Clearinghouse Rule 18-007
PUBLIC SERVICE COMMISSION OF WISCONSIN

In the Matter of the Proposed Revision of Wis. Admin. Code ch. PSC 114 as
Wisconsin State Electrical Code, Volume I

1-AC-250

NOTICE OF HEARING

Figure PSC 114-317B1.

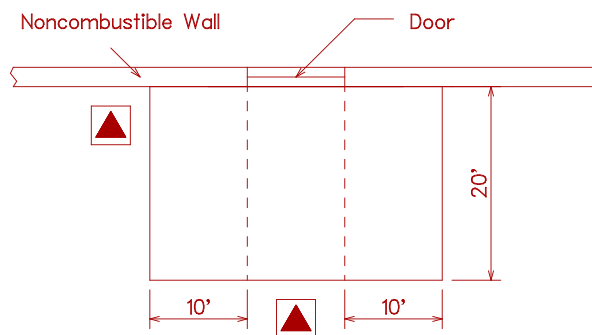
1. Padmounted oil-insulated transformers shall not be located within a zone extending 6.1 m (20 ft) outward and 3.0 m (10 ft) to either side of a building door. See Figure PSC 114-317B1.

Figure PSC 114-317B2.

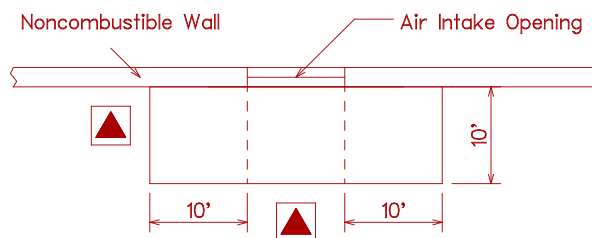
2. Padmounted oil-insulated transformers shall not be located within a zone extending 3.0 m (10 ft) outward and 3.0 m (10 ft) to either side of an air intake opening. Such transformers may be located within said zone beneath an air intake opening provided there is not less than 7.6 m (25 ft) diagonal separation between the transformer and said opening. See Figure PSC 114-317B2.

Figure PSC 114-317B3a.

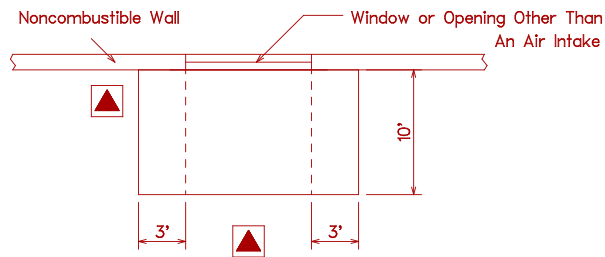
- 3.a. Padmounted oil-insulated transformers shall not be located within a zone extending 3.0 m (10 ft) outward and 0.9 m (3 ft) to either side of a building window or opening other than an air intake. See Figure PSC 114-317B3a.

Exception: This does not apply to a glass block or fire window meeting the requirements of the Wisconsin Commercial Building Code (Fire Window IBC Chapter 7, Section 714.3).

Figure PSC 114-317 B3b.

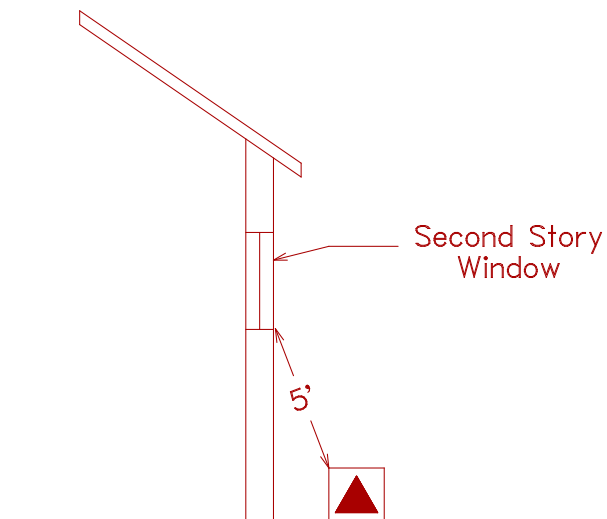
3.b. For second story windows, the transformer shall not be located less than 1.5 m (5 ft) from any part of the window. See Figure PSC 317B3b.

Exception: This does not apply to a glass block or fire window meeting the requirements of the Wisconsin Commercial Building Code (Fire Window, IBC Chapter 7, Section 714.3).

Figure PSC 114-317D1.

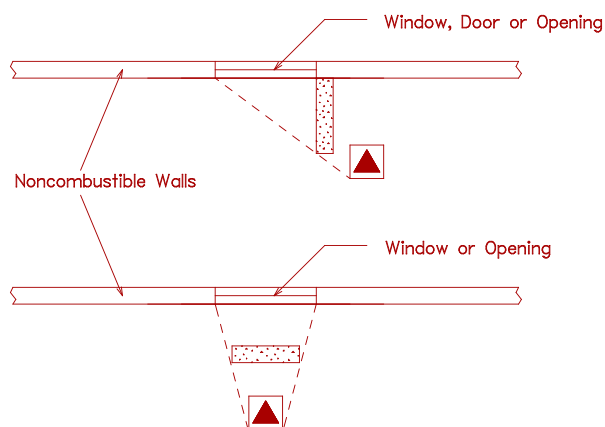
The barrier shall extend to a projection line from the corner of the padmounted transformer to the furthest corner of the window, door or opening in question. The height of the barrier shall be 0.3 m (1 ft) above the top of the padmounted transformer. See Figure PSC 114-317D1.

Figure PSC 114-317D2.

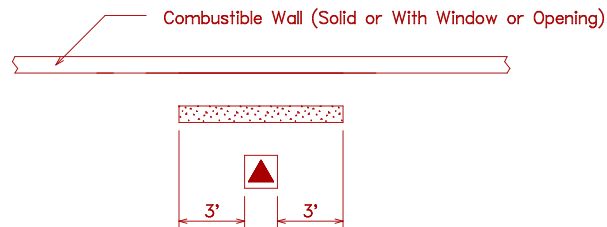
The barrier shall extend 0.9 m (3 ft) beyond each side of the padmounted transformer. The height of the barrier shall be 0.3 m (1 ft) above the top of the transformer. See Figure PSC 114-317D2.

Figure PSC 114-317E1

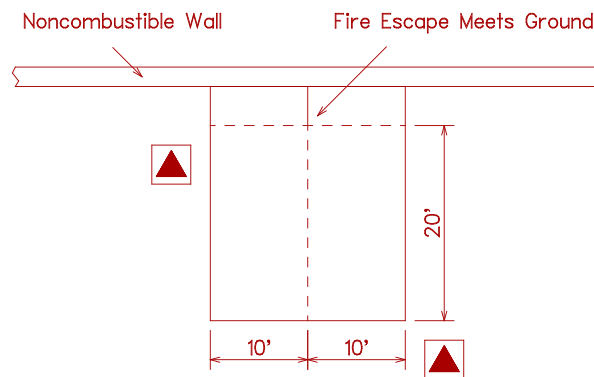
1. Padmounted oil-insulated transformers shall not be located within a zone extending 6.1 m (20 ft) outward and 3 m (10 ft) to either side of the point where a fire escape meets the ground. See Figure PSC 114-317E1.

Figure PSC 114-317E2

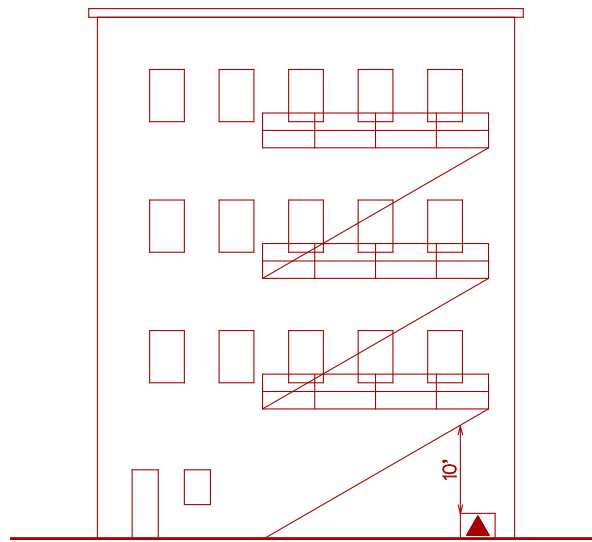
2. Padmounted oil-insulated transformers located beneath fire escapes shall have a vertical clearance of not less than 3 m (10 ft) from the top of the transformer to the bottom of the fire escape. See Figure PSC 114-317E2.
